Your Ref
FP/109/11/
Our Ref
S/AR/2011/109
Date: 02/08/2011

Erection of 1 No bungalow with associated parking and external works
(Resubmission of FP/241/10/).
21 Uppark Way Bognor Regis PO22 6QQ
FP/109/11/ — PLS scan + file

Southern Water MapGuide Browser

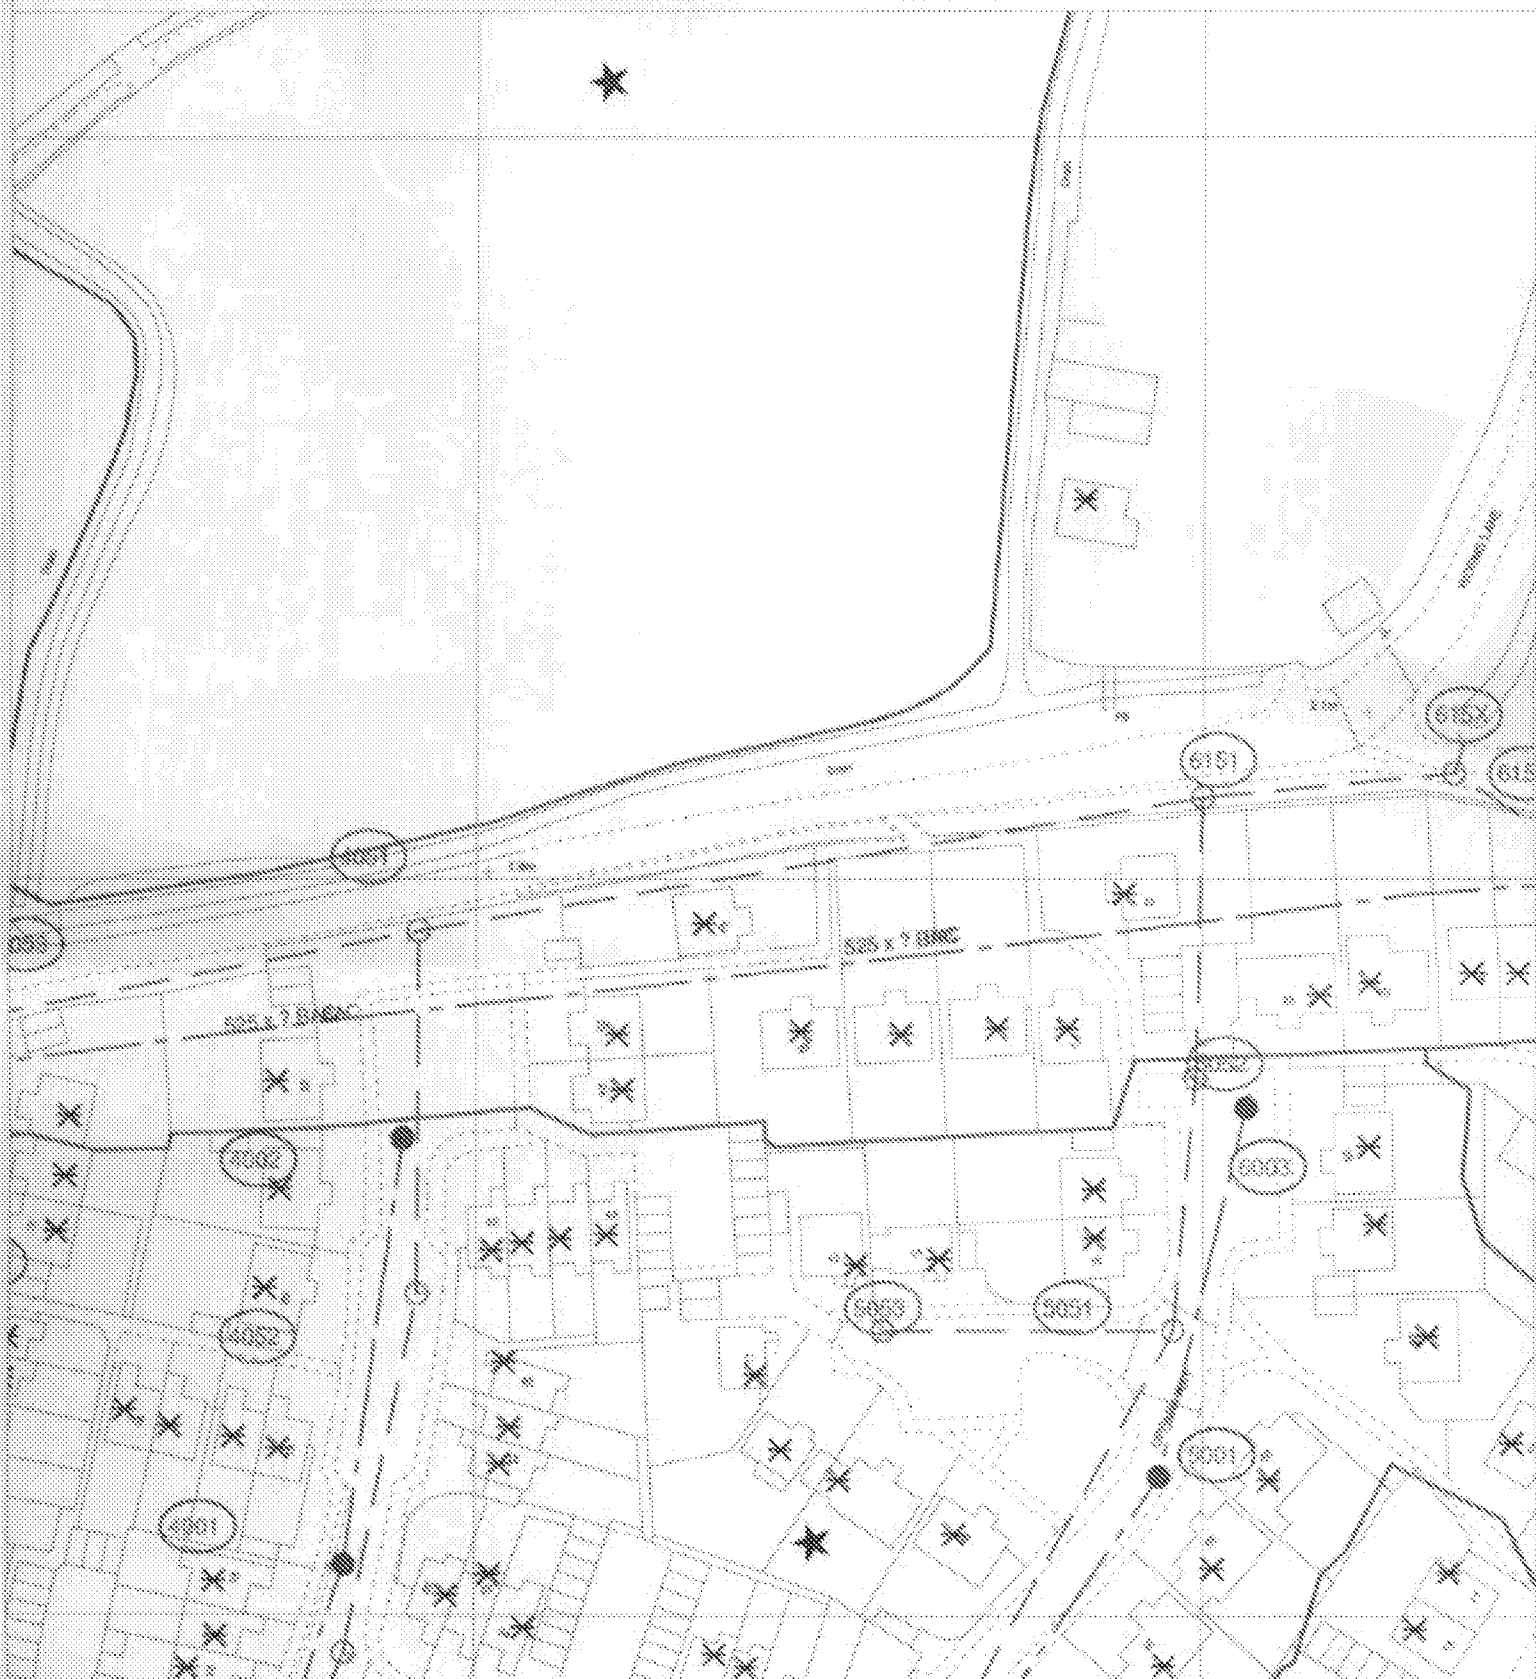
Please find attached a plan of the sewer records showing the approximate position of public surface water sewers (525mm & 150mm) crossing the site. The exact position of the public sewers must be determined on site by the applicant before the layout of the proposed development is finalised.

1. The 525 mm diameter sewer requires a clearance of 3.5 metres either side of the sewer to protect it from construction works and allow for future access for maintenance.
2. No development or new tree planting should be located within 3 metres either side of the centreline of the 150mm diameter public sewer.
3. No new soakaways should be located within 5m of a public sewer.
4. All other existing infrastructure should be protected during the course of construction works.
